WSC Building Plan Approval Summary Subject to Requirements

Job Address:	LOT 1 NO.74 SOLDIERS AVENUE FRESHWATER 2096
Building/Structure Description:	New Residence
Sydney Water Tap-In Reference:	1666321
Date Approval Issued:	30/08/2023
Architectural Site Plan Revision:	2
Structural Engineers Revision:	B

**SYDNEY WATER
BUILDING PLAN APPROVED -
SUBJECT TO REQUIREMENTS**

SERVICE PROTECTION REPORT

Your building plan application needs further assessment
Structure 2 of 2: WATER TANK

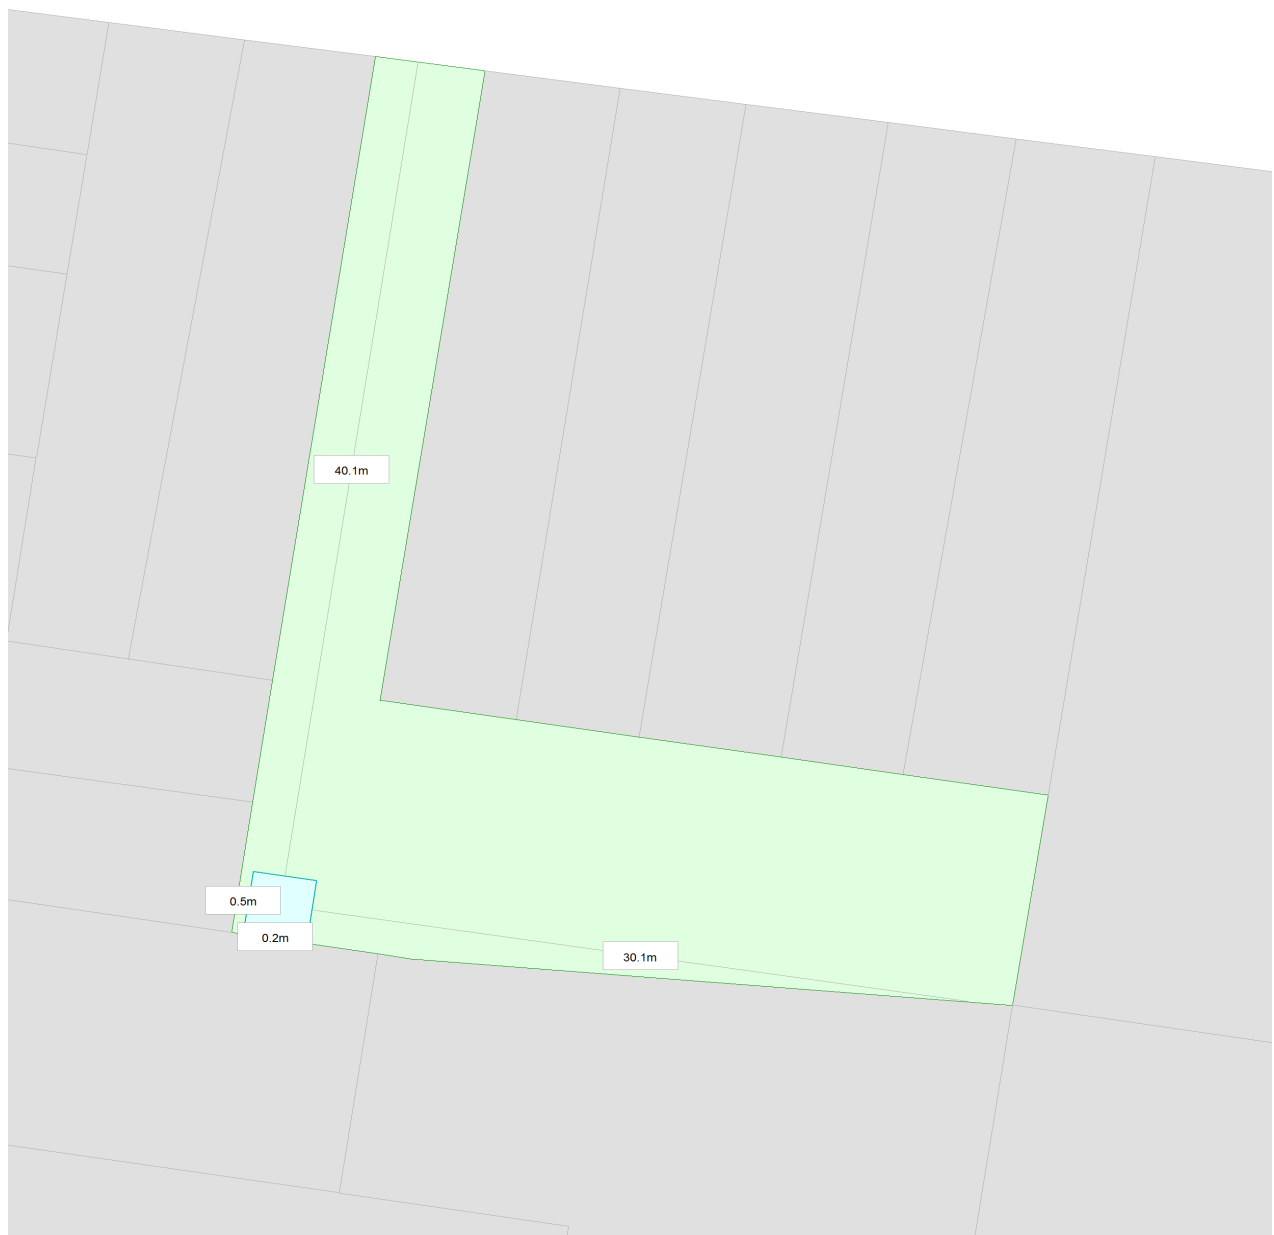
This structure may impact Sydney Water infrastructure.

1. Main within work site. Sewer Main; Asset Number: 3401664.

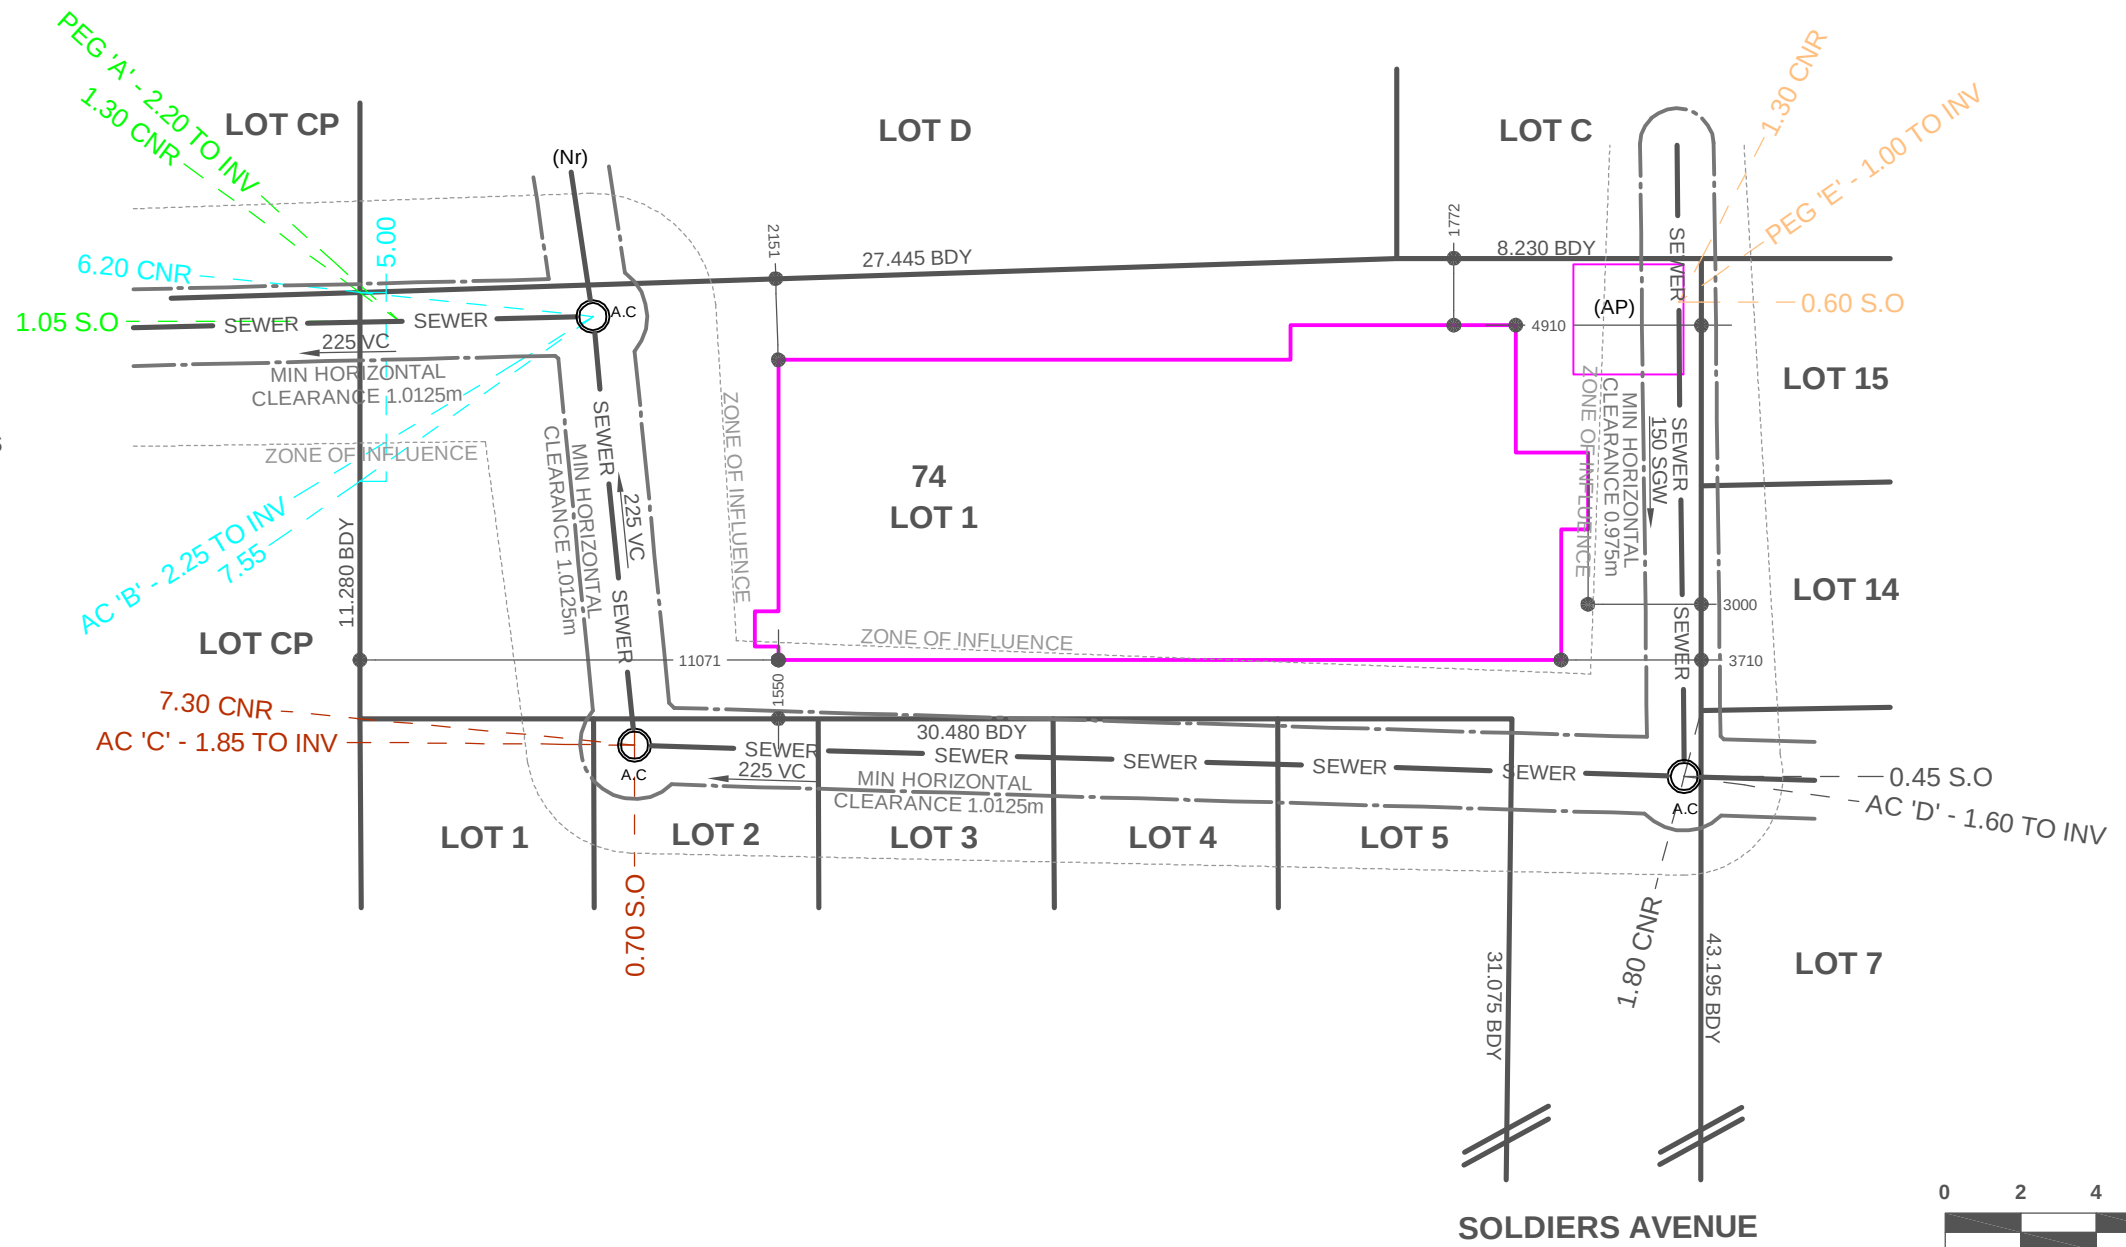
Please note all Sewer location ties are shown from existing fence's located onsite at time of survey.

NOTICE
BUILDER TO
REVIEW
DRAINAGE
REQUIREMENTS
